Product Change Notification

1. ECR #: 213435
Notification #: 634

- ISDE - 0.8MM SESD BODY
- SESDT - 0.80MM SOCKET DISCRETE WIRE ASSEMBLY

4. Part #'s Affected

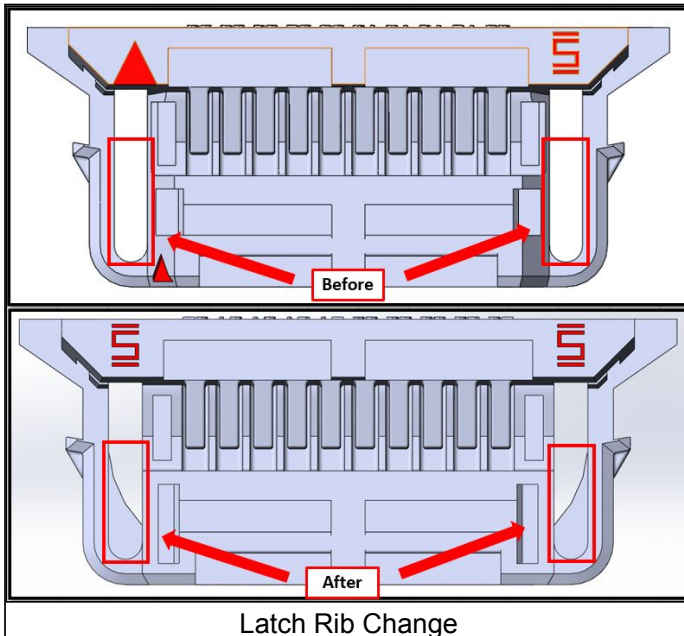
Adding ribs underneath both latch arms.

Improve latching action by updating latch geometry to current design standard. This will not be a rolling change and only new revision bodies will be received after this change is complete.

- Form - Visual change with adding ribs underneath the latch arm.
